Road Safety Audit Report

Site Access and Bus Stop Relocation

1157 -1165 Burwood Highway, Upper Ferntree Gully

Functional Design Stage

Burwood Highway eastbound – channelised right turn (red circle indicates approx. location of new access)

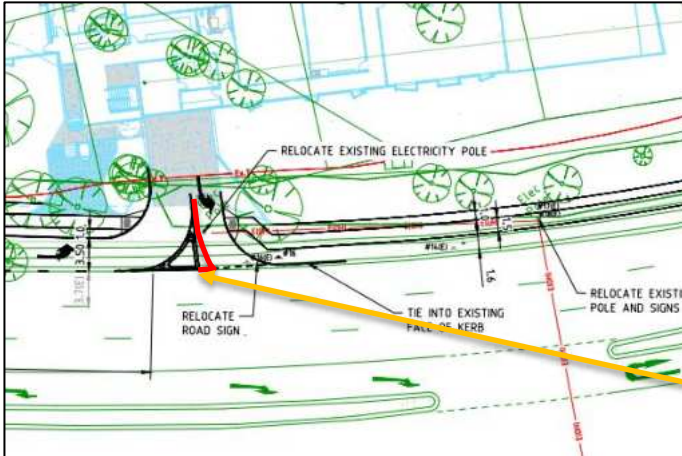
There will be a left-in / left-out access along Burwood Highway eastbound. However, there is an existing channelised right turn (CHR) fronting the new access. Left turners from the subject site heading westbound may travel across multiple lanes over the eastbound carriageway of Burwood Highway and enter the CHR, increasing the risk of conflict with approaching traffic, including side-impact crashes.

The following options could assist with discouraging drivers from traversing multiple lanes on the eastbound carriageway of Burwood Highway:

- Provide line marking at the exit at an angle to the eastbound carriageway.
- Display 'left turn only' sign R2-14 (L).

Sheet 1 of layout plan

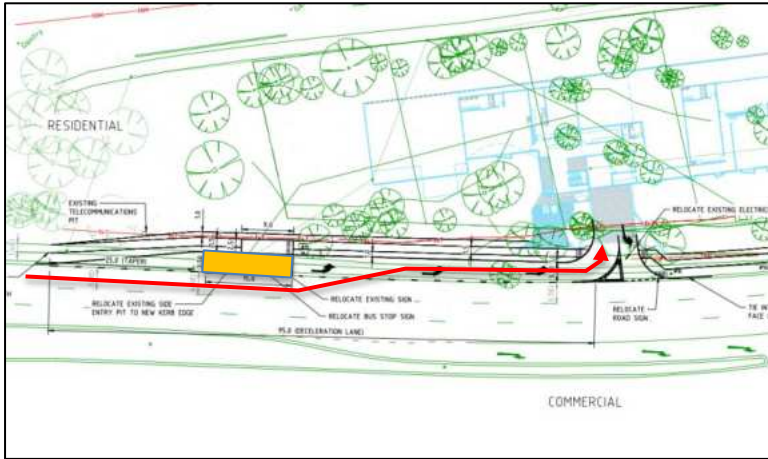
The relocated bus stop is at the commencement of the deceleration lane. If buses are stopped at the bus stop, left turners will need to enter the left turn lane after the bus stop. This effectively reduces the deceleration length (i.e. $95-25-15 = 55$ m), which increases the potential for rear-end crashes as motorists will need to commence their deceleration in the through traffic lane.
